To: Honorable Mayor Patrick Collins and Members of the City Council
From: Connor White, Planner II
Subject: PUDC-24-32 / Carey Cottages / Final Plat
Date: April 8, 2024

CAREY COTTAGES

CITY OF CHEYENNE PLANNING COMMISSION
April 1, 2024
STAFF REPORT

FILE: PUDC-24-32: Carey Cottages (Expedited Review)

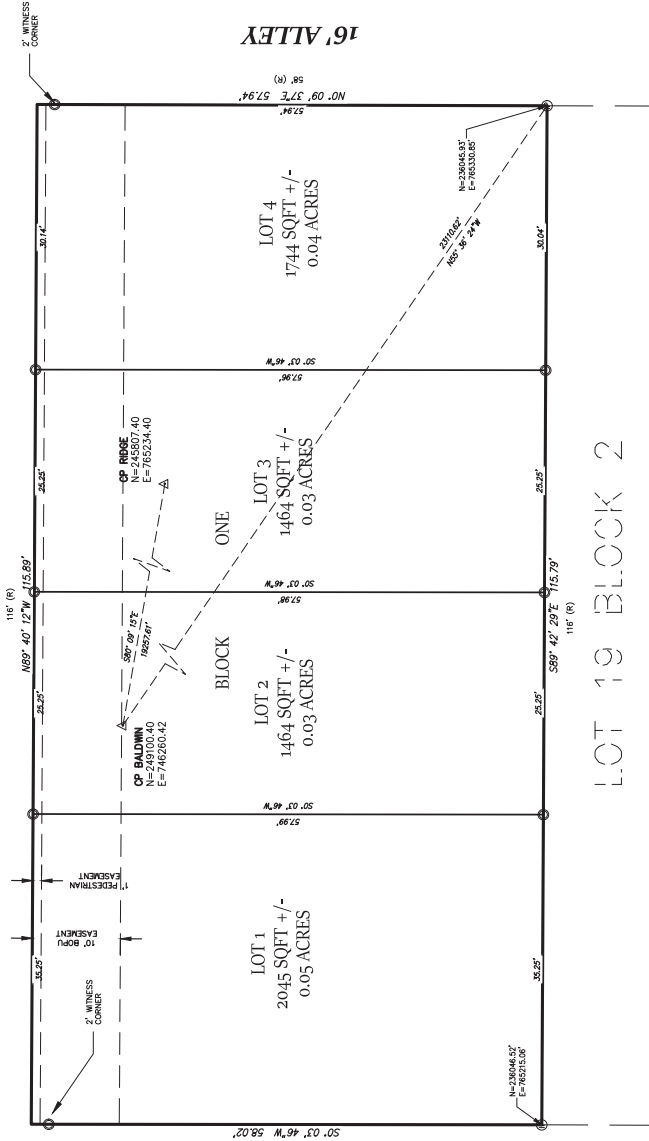
1. Acknowledgements of relief:
 - a. Access to a street for lots less than 36' wide (Subdivision Standards Waiver)
 - b. Reduction in a rear setback (Administrative Adjustment)
2. Prior to recording:
 - a. The 10-foot BOPU easement be changed to just a utility easement along Cheyenne Street.

The Planning Commission Staff report is attached. Prior to Planning Commission a new Plat map was submitted to staff which addressed the conditions within the staff report. Upon further review, BOPU would prefer the easement along Cheyenne Street to be just a utility easement which is why there is a condition to change it to a generic utility easement.

CAREY
COTTAGES

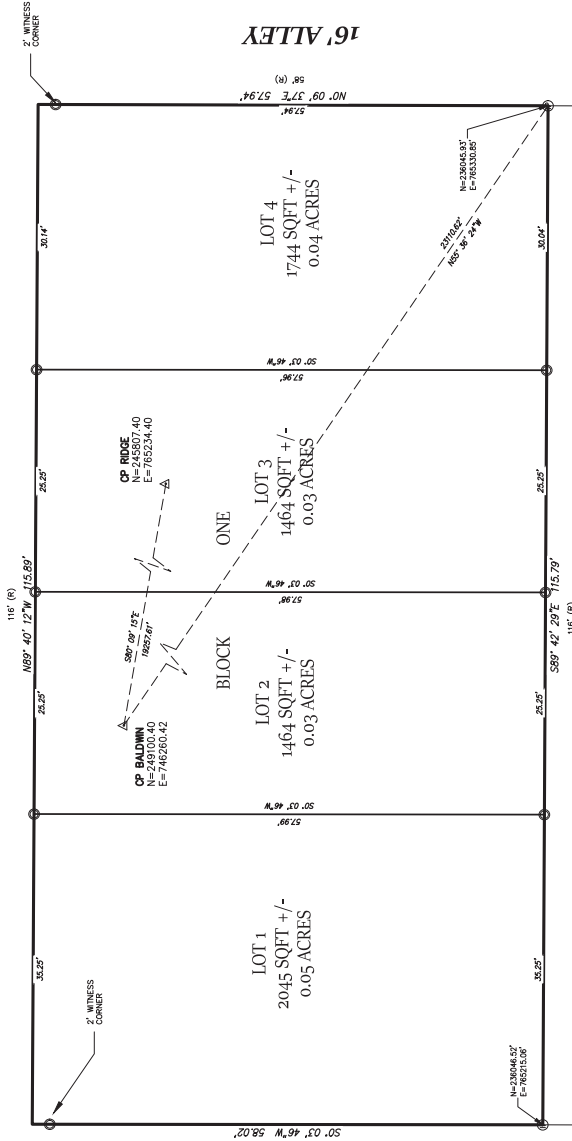
1. Minor clerical corrections.
2. Utility and easement correction.

1. Acknowledgements of relief:
 - a. Access to a street for lots less than 36' wide (Subdivision Standards Waiver)
 - b. Reduction in a rear setback (Administrative Adjustment)
2. Prior to recording:
 - a. A 10-foot utility easement be added along Cheyenne Street.
 - b. A Public access easement be added along Cheyenne Street for a 6-foot attached sidewalk.
